AUGUST 6, 2025

PROJECT NO: 624-6777

RE: PROLOGIS HUMBER STATION – TEMPORARY STORMWATER MANAGEMENT OUTLET

Project	HUMBER STATION DISTRIBUTION CENTRE TOWN OF CALEDON
Drawing	INTERIM CONDITIONS DIVERTED DRAINAGE AREAS

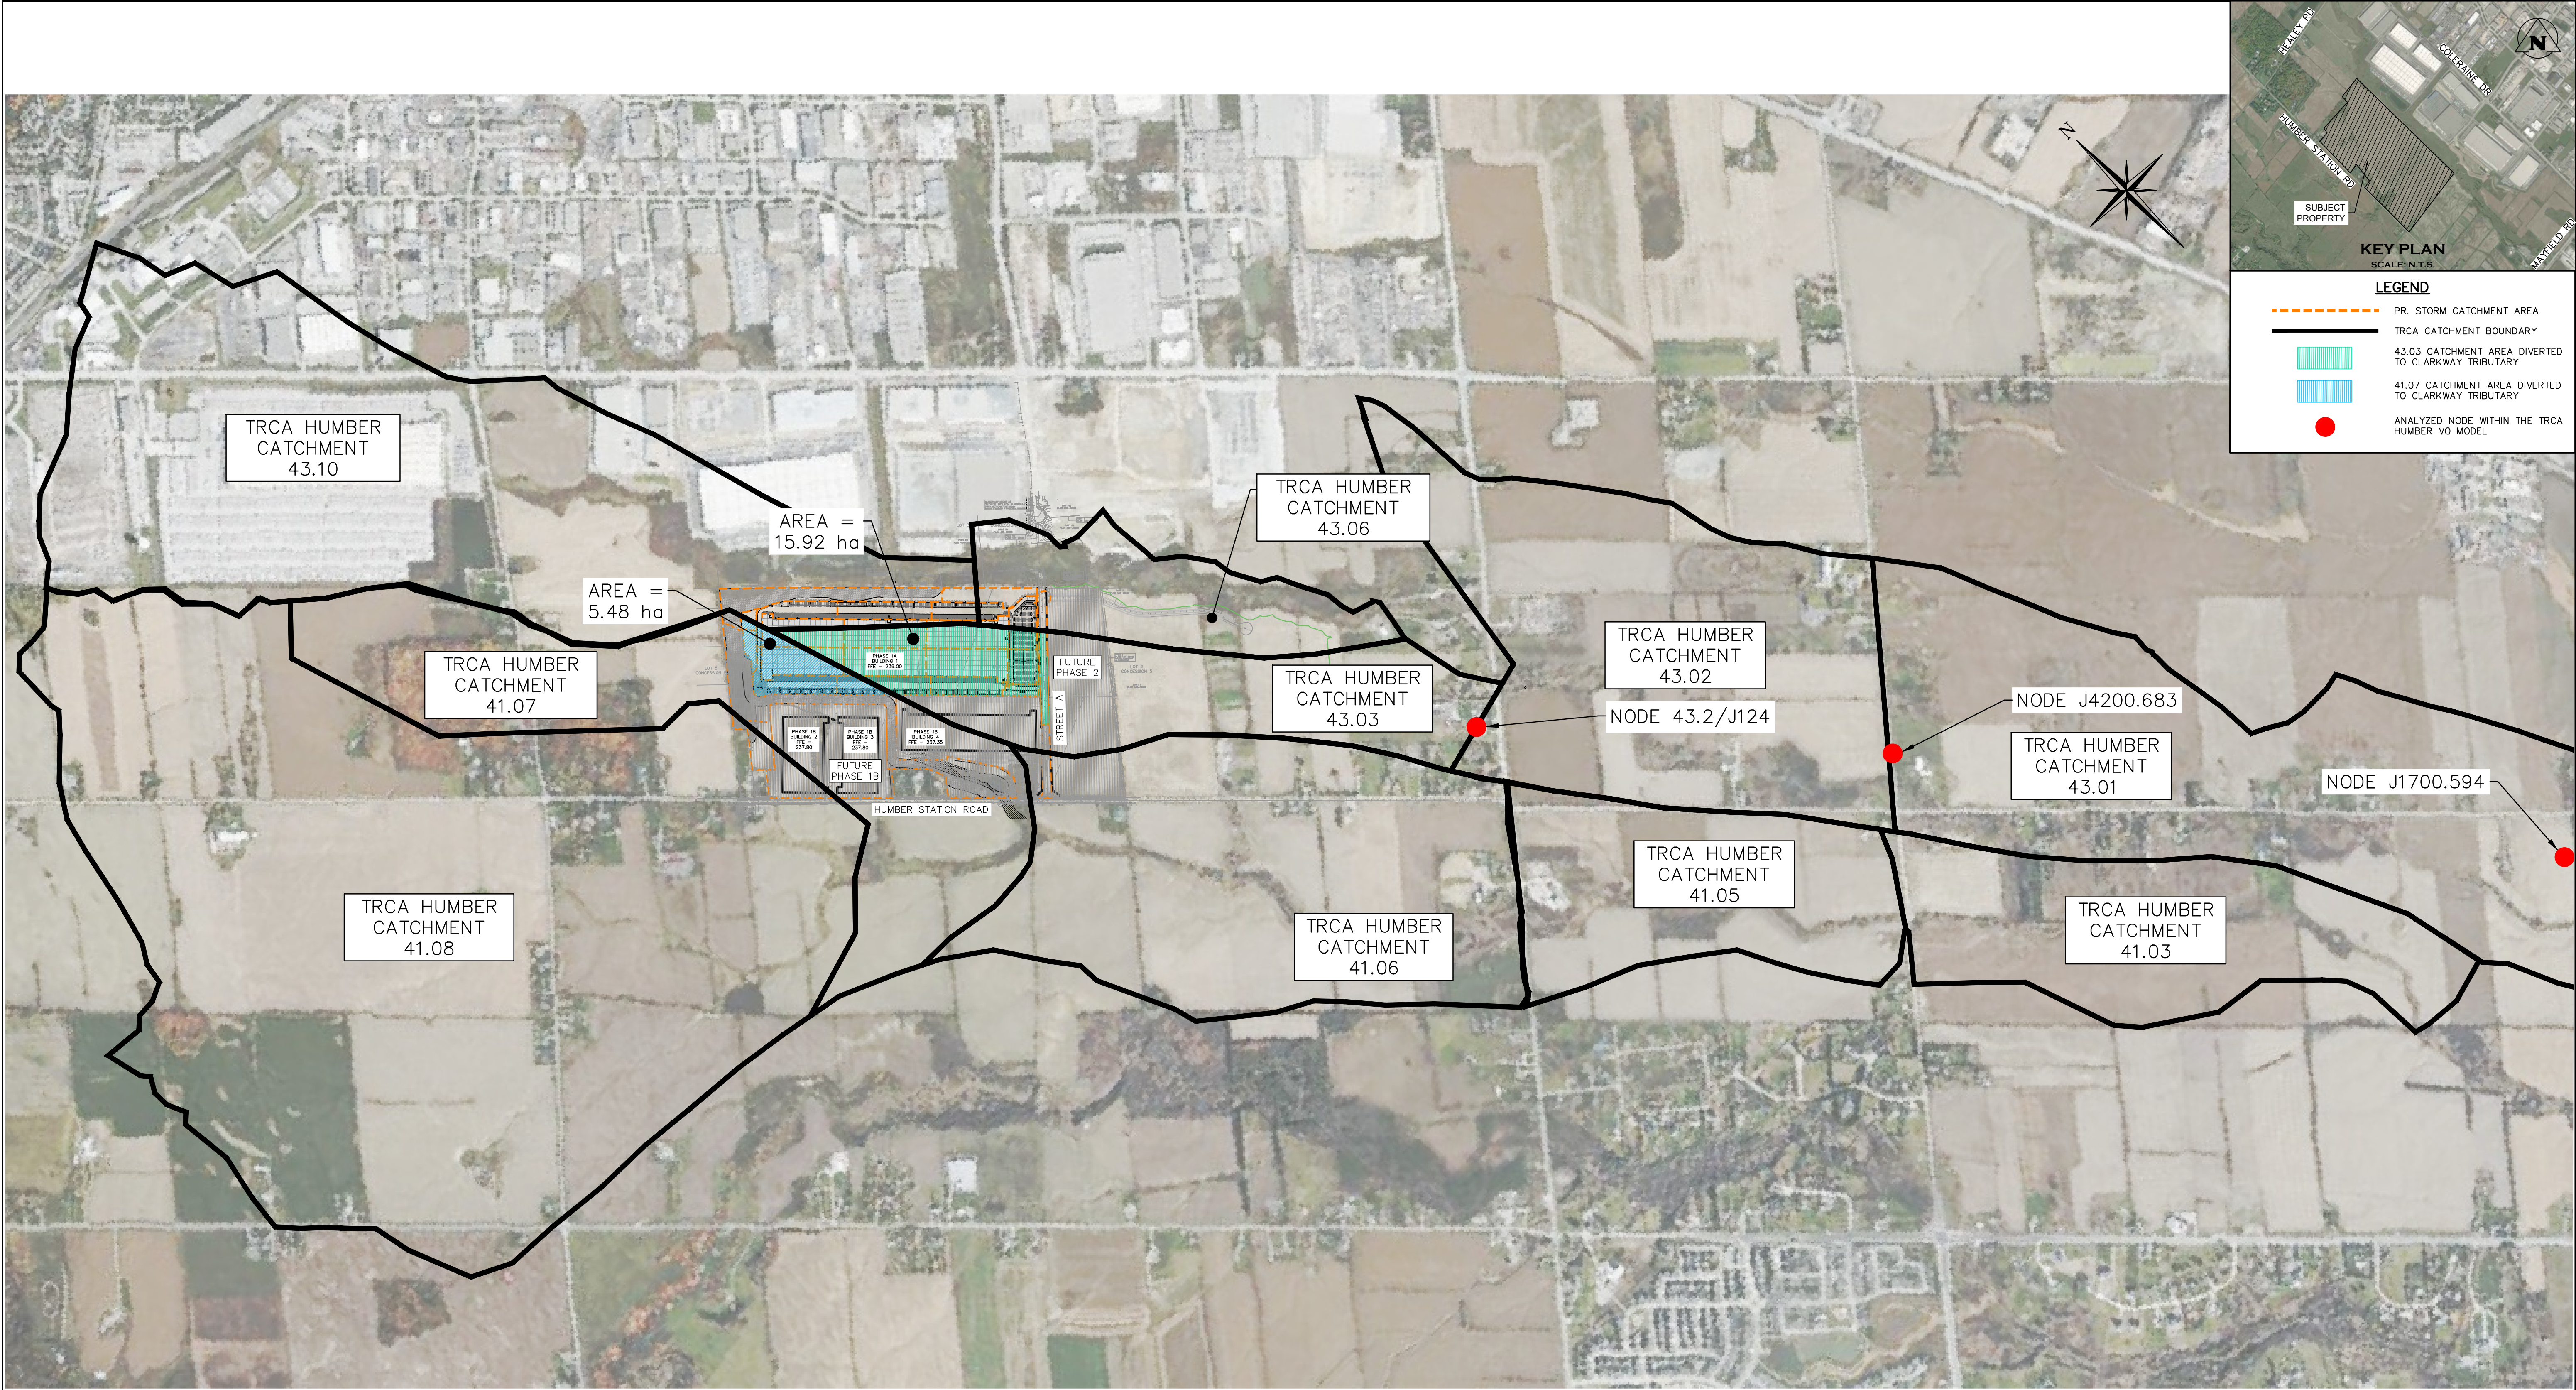
3. *Identify contributing drainage area to the proposed interim outlet location in Clarkway Tributary and summarize in a drainage map.*
 - a. *Compare the upstream area and diversion area.*

Figure 2 attached shows the post-development catchment areas from Phase 1A that are to drain to the interim outlet location as well as the proposed SWM facility. **Figure 3** shows the upstream area contributing to the tributary and highlights the areas within Phase 1A that are proposed to be diverted. The diverted area is summarized in the table below. As

shown, the 15.92 ha diverted area is very minor in comparison to the total 651.60 ha contributing area, representing 2.4% of the total area.
